### ARCHITECTURAL REVIEW BOARD

#### AGENDA

February 25, 2016

#### Staff Analysis COAP 16-1

JOB H & C TOWNHOUSES		WARRENTON, VIRGINIA 20186	
SMITH & DIAGONAL STREETS		WARRENTON, VIRGINIA 20186	
SHEET SITE PLAN		REVISION	DWG SP-1
COMM NO. 995	DRAWN PK	SCALE 3/8" = 1'-0"	DATE 01-20-16

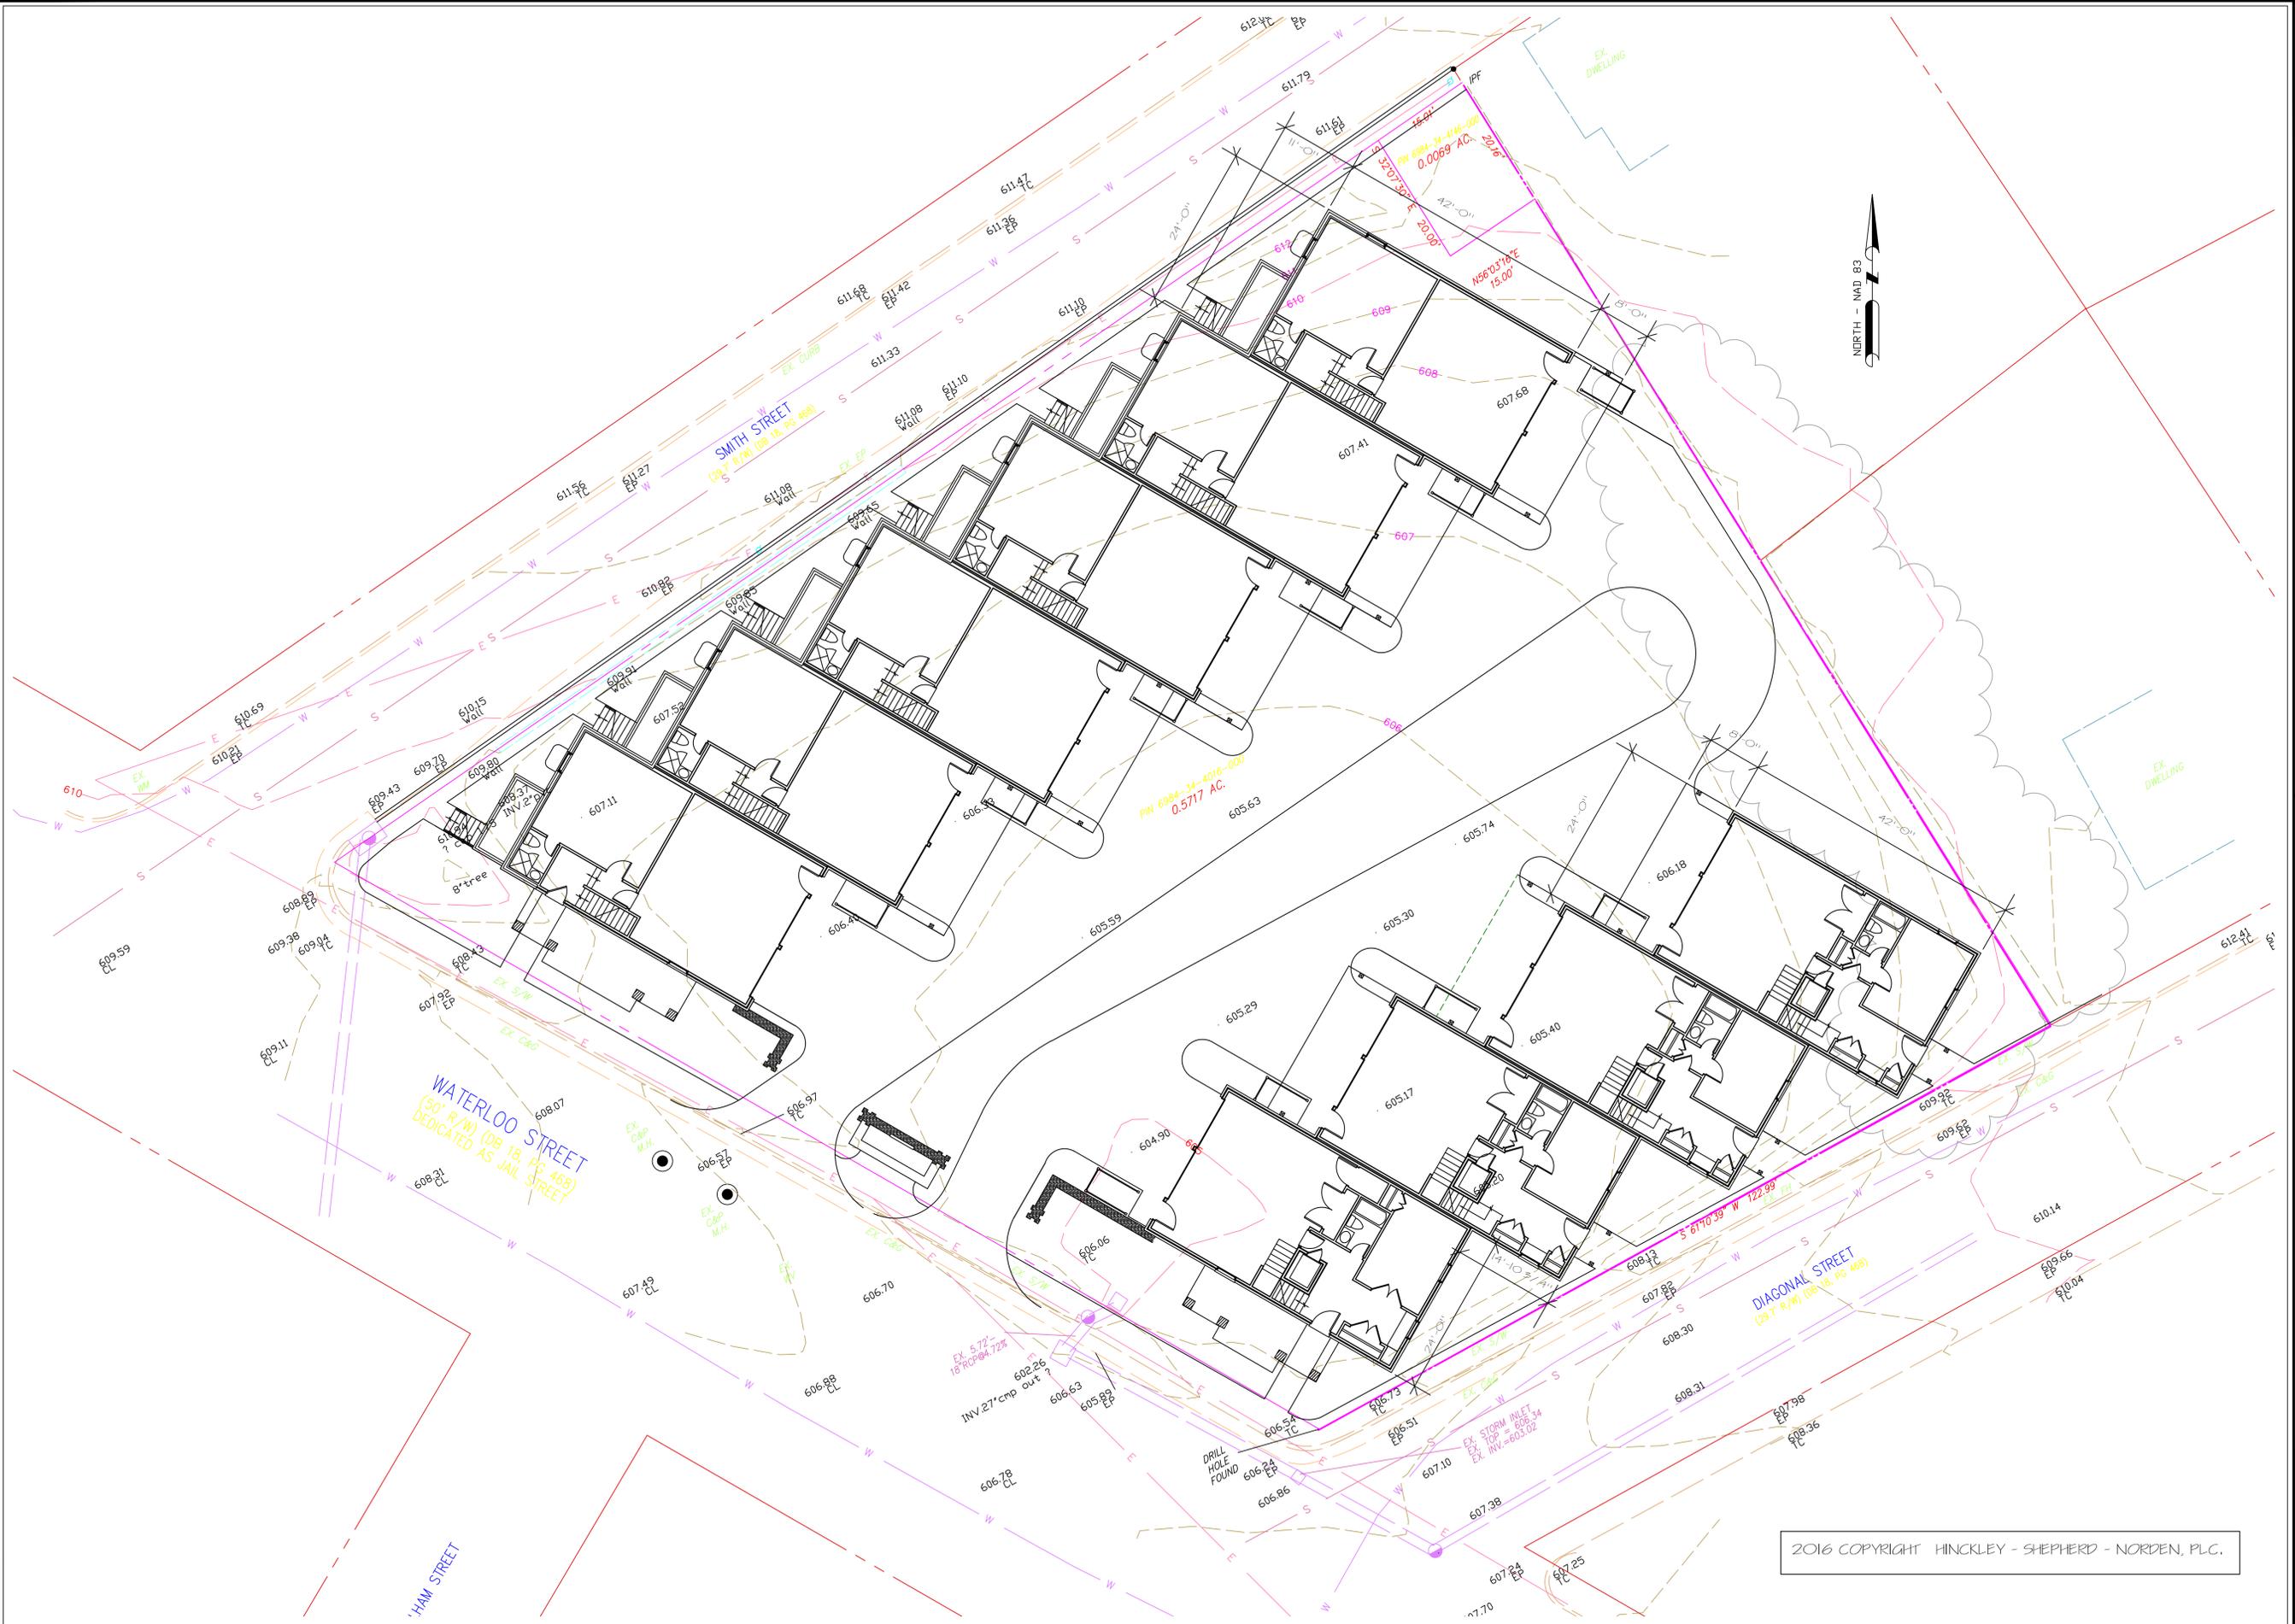
<b>Architectural Review Board Comment</b>	<b>Applicant's Response</b>
North direction is not shown.	Please see the Site Plan Sheets (SP-1 and SP-2) where the north direction is clearly depicted.
No dimensions are presented.	Please see the Site Plan Sheets (SP-2) where dimensions are clearly depicted.
No topography has been shown.	Please see the Site Plan Sheets (SP-2) where topography is depicted. Topography is not depicted on each sheet, but is depicted on SP-2.
No grading or finished grading is shown.	Final grading is not available at this stage but will be provided as part of the site/subdivision plan process, as is customary.
No lighting has been shown.	Please see the Architectural Drawings where typical lighting is depicted.
No landscape materials, trees and other items are shown.	Please see the Site Plan Sheets (SP-I) where landscaping is depicted. Actual/final selections will be made in connection with site/subdivision plan review.

<b>Architectural Review Board Comment</b>	<b>Applicant's Response</b>
North direction is not shown.	Please see the Site Plan Sheets (SP-1 and SP-2) where the north direction is clearly depicted.
No dimensions are presented.	Please see the Site Plan Sheets (SP-2) where dimensions are clearly depicted.
No topography has been shown.	Please see the Site Plan Sheets (SP-2) where topography is depicted. Topography is not depicted on each sheet, but is depicted on SP-2.
No grading or finished grading is shown.	Final grading is not available at this stage but will be provided as part of the site/subdivision plan process, as is customary.

FRONT ELEVATION - 3-STORY PORCH @ WATERLOO & DIAGONAL STREETS  
SCALE 1/4" = 1'-0"

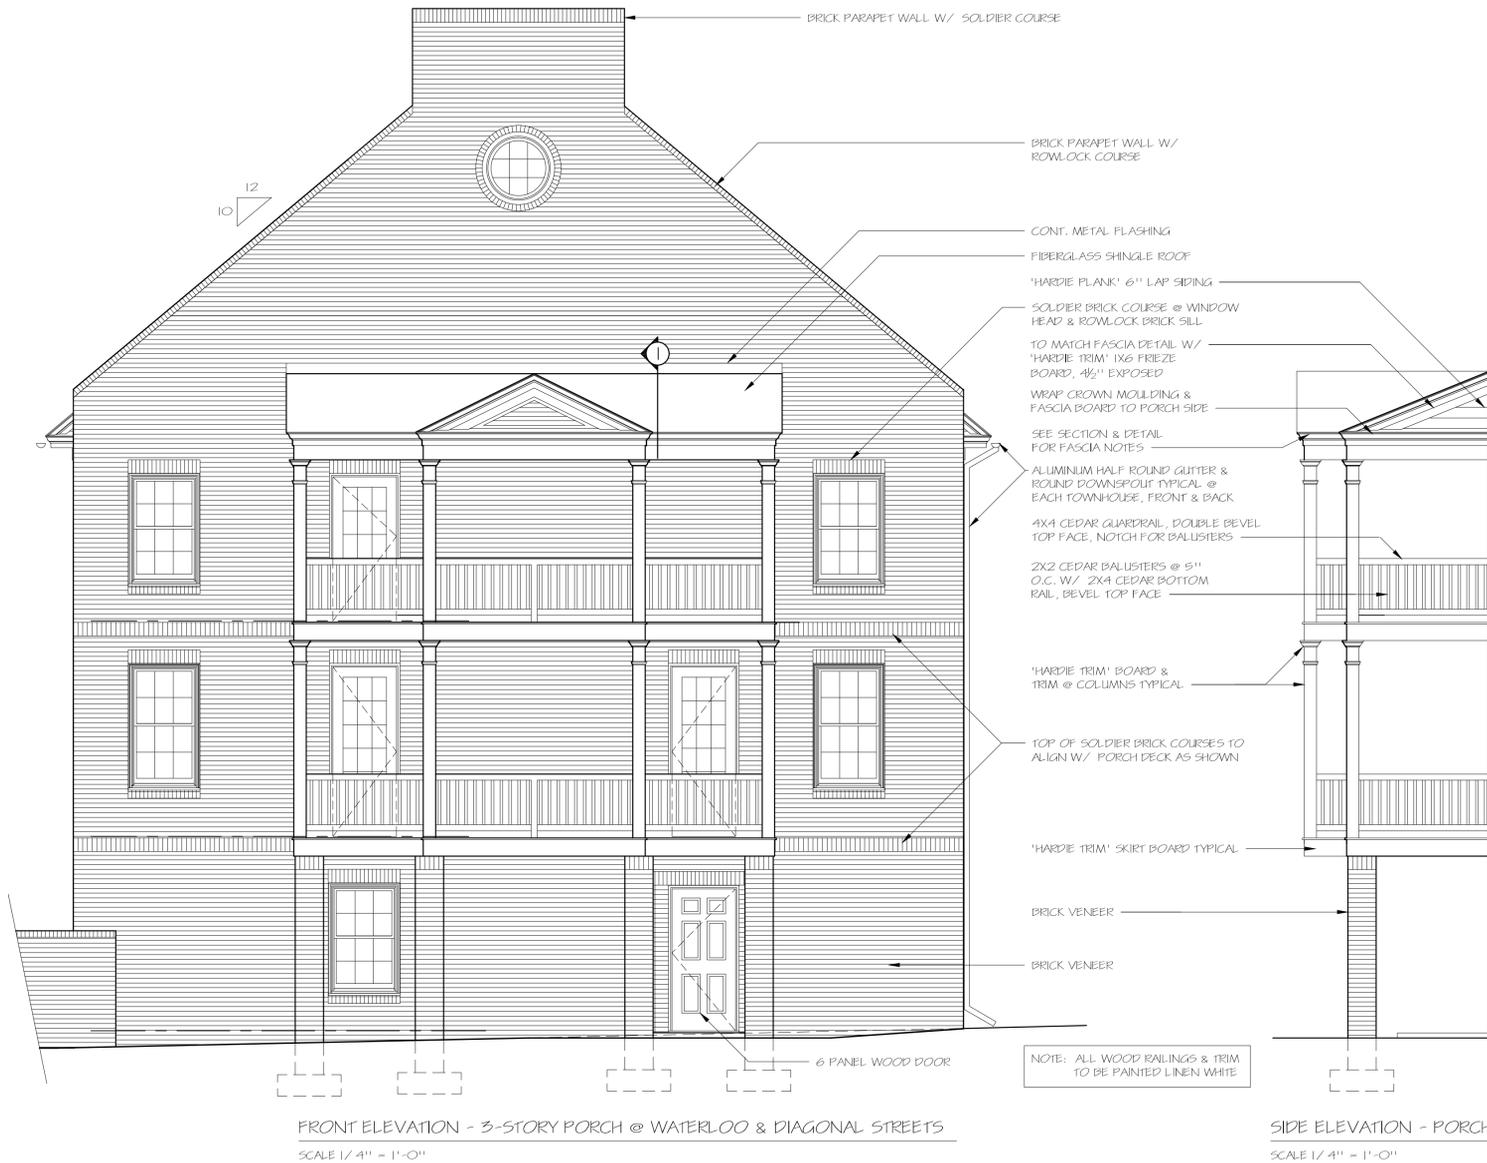
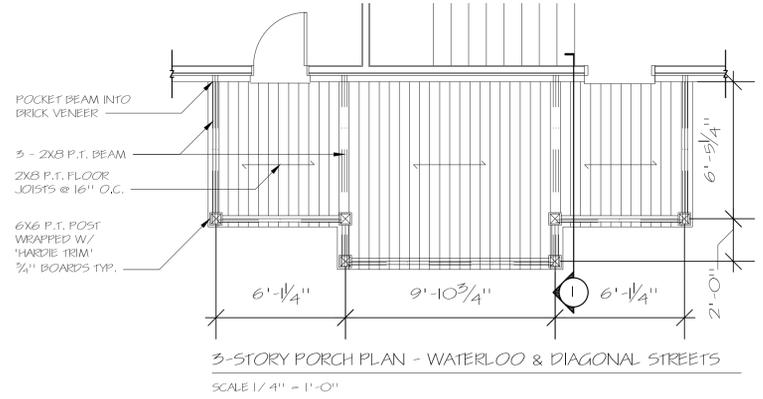
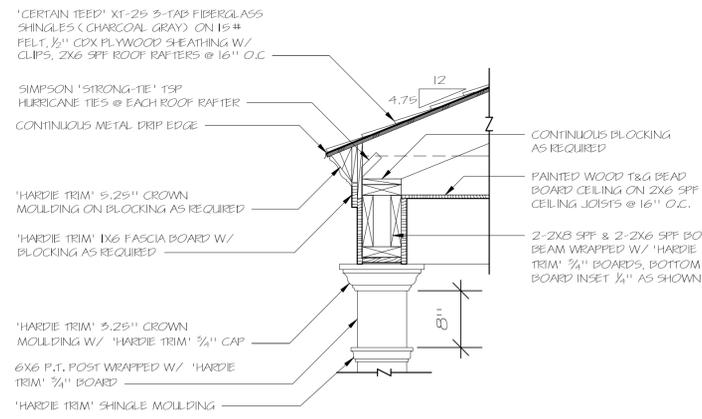
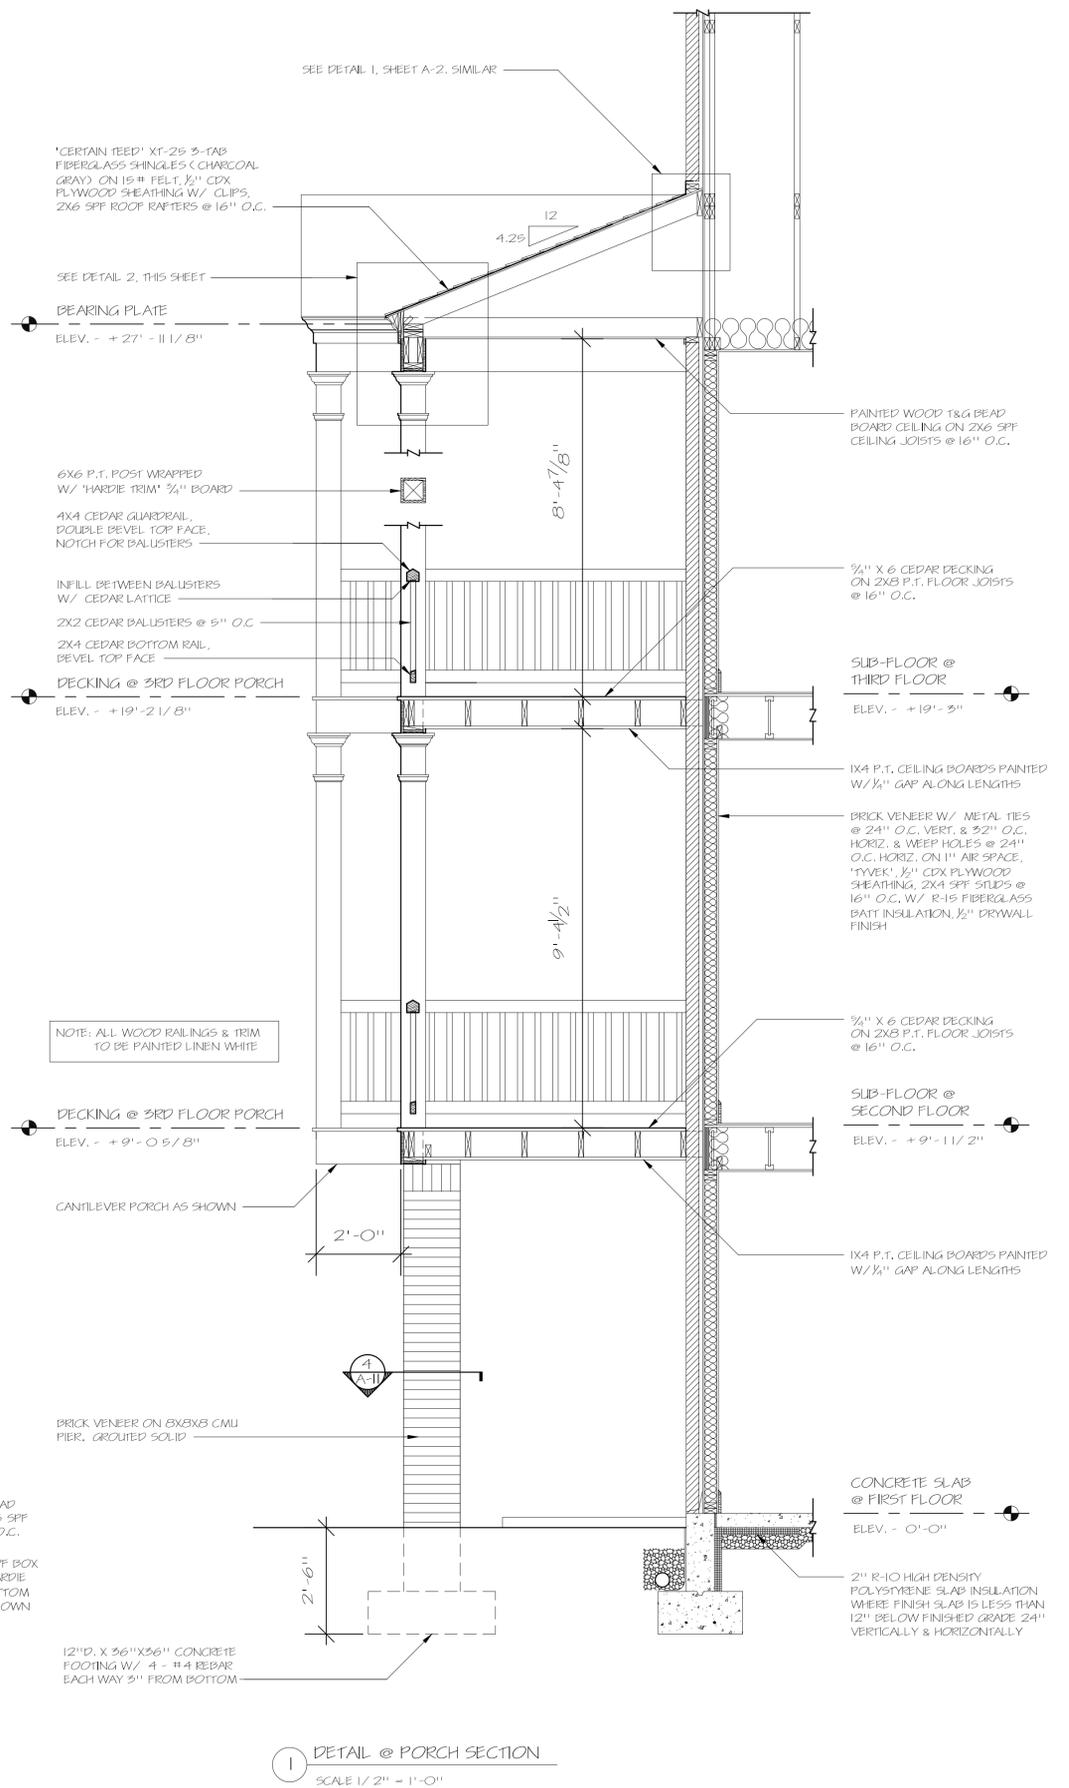
- Three-story porches on the Waterloo Street elevations for the end units,
- There is an alternative plan sheet '6a' that includes 4<sup>th</sup> story use of attic space and includes roof decks for the Diagonal Street elevations,
- 'Hardie Plank' siding removed from the offset gables and replaced with brick,
- The internal pavement/roadway will be stamped concrete,
- The buildings and sidewalk along Smith Street have been separated for more green space and planting area, and
- Fenced enclosures have been designed to screen HVAC compressors and gas meters.

Three story porches were added to the Waterloo Street elevations. The rear decks on the first two units closest to Waterloo Street would no longer be located at the rear, but on the elevations facing the street. The elevations would have window and door placement in relationship to the three porch levels and the porch materials would consist of 'Hardie Trim' boards and mouldings.

- Three story porches have been added to the Waterloo Street elevations. This will make each building end elevation appear to be an individual residence facing Waterloo Street, thus continuing the rhythm of the street. It also allowed the removal of the back decks on the first two units.

FIRST FLOOR PLAN - A/C ENCLOSURE  
SCALE 1/4" = 1'-0"

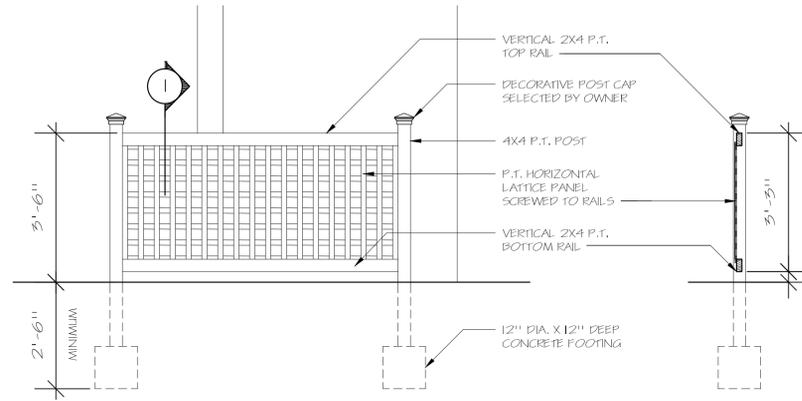
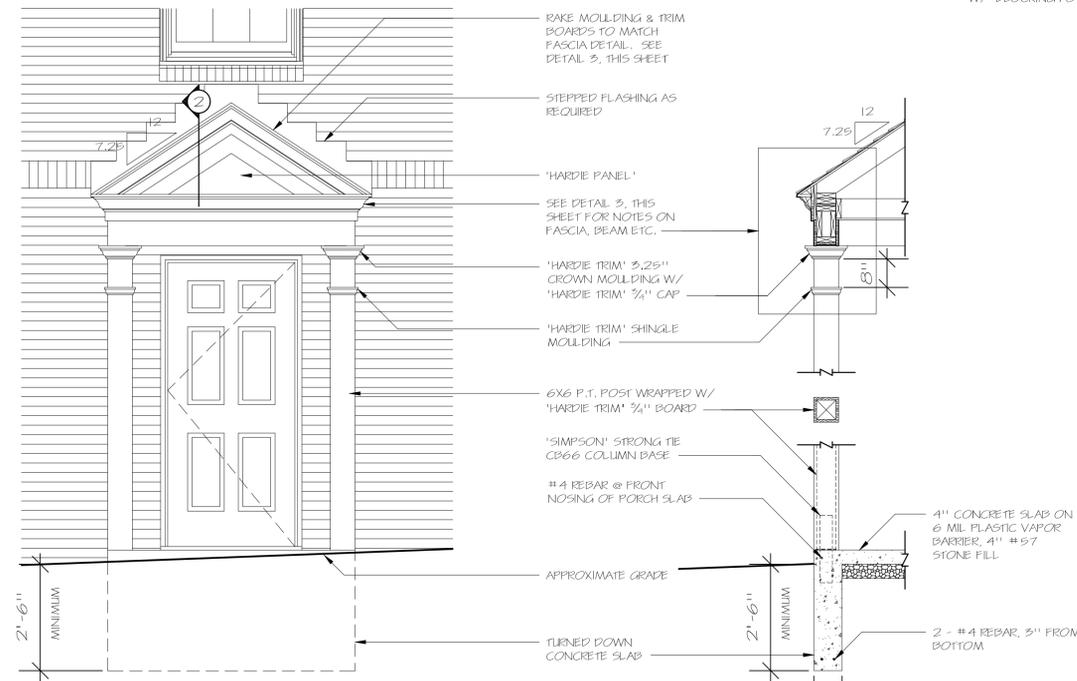
There will not be any exposed carriages.
Mechanical equipment including air conditioning condensers & disconnects are not shown.	Please see the Architectural Drawings (A-12). The mechanical equipment would be located out of sight on the roof balcony if the habitable attic plan is permitted.
Exterior lighting fixtures type, style, location and details are not shown.	Please see the Architectural Drawings.
Electrical service and meter locations are not shown.	The Applicant expects to work with Virginia Power to have meters placed in a location on-site but remote from individual homes. The Applicant's architect has done this on other projects.
Gas meters if proposed are not shown.	Gas meters are proposed since gas fireplaces will likely be incorporated and are expected to be located behind a fence with the HVAC units. The Applicant will work with the gas company on the location of the gas meters.

- The buildings and sidewalk along Smith Street have been separated to allow for more green space and planting area in front of those buildings.
- Fenced enclosures have been designed to screen the HVAC compressors and gas meters.
